Access Compliance Report

Public Rights-of-Way (Curb Ramps)

Intersection ID: N/A	Main Street: KIMMERLY_GLEN_LN	Cross Street: KIMMERLY_CREEK_DR	Location: NW
ADA ID: 92903CF07AC1	Ramp Type: Directional	Initial Pass/Fail: Pass	Overall Compliance: No Severity Score: 10.25

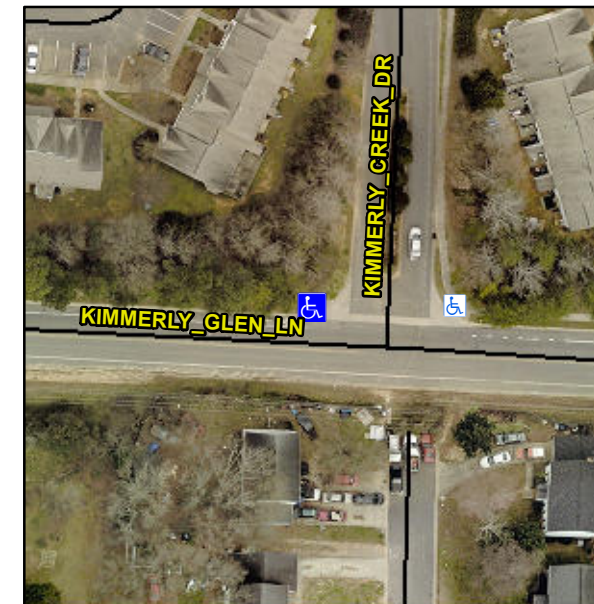
Compliance	Description	Data	Compliance	Description	Data
N/A	Ramp Length (in)	89.0	Yes	Grade Break?	Yes
Yes	Ramp Width (in)	50.0	Yes	Grade Break Slope (%)	0.3
Yes	Ramp Slope (%)	1.7	No	Grade Break XSlope (%)	4.0
No	Ramp XSlope (%)	2.3			
N/A	Flare Type LT	N/A	N/A	Flare Type RT	N/A
N/A	Flare Slope LT (%)	2.9	N/A	Flare Slope RT (%)	1.9
N/A	Flare Traversable LT?	No	N/A	Flare Traversable RT?	No
Yes	Landing Length (in)	51.5	No	DWS Provided?	No
Yes	Landing Width (in)	48.0	N/A	DWS Contrast?	No
No	Landing Slope (%)	2.1	N/A	DWS Length (in)	N/A
No	Landing X Slope (%)	3.9	N/A	DWS Full Width?	No
N/A	Landing Curb? (Y/N)	N/A	N/A	DWS Offset LT (in)	N/A
N/A	Shared Landing?	No	N/A	DWS Offset RT (in)	N/A
Yes	Gutter Ponding?	No	Yes	Gutter Slope (%)	0.8
Yes	Gutter Lip Ht (in)	0.0	Yes	Gutter X Slope (%)	0.4
N/A	Painted X Walk1?	No		Road Slope (%)	1.7
	X Walk 1 Direction	To E		Road X Slope (%)	0.0
	X Walk 1 Width (in)	N/A		Clear Space?	Yes

X Walk 1 Slope (%)	1.7	N/A	Clear Space to XWalk (in)	N/A
	X Walk 1 X Slope (%)	0.0	Yes	Storm Grate/Utility Hazard?	No
N/A	Ramp inside XWalk1?	N/A		Storm Grate/Utility Type	
Yes	Any Obstructions?	No			N/A
	Obstruction Type		Yes	Surface Condition? (G/P)	Good
			N/A	Curb Slope (%)	8.7

Remove & Replace Entire Ramp.

R304.5.3, R304.2.2-Perp, R304.3.2-Para, R305
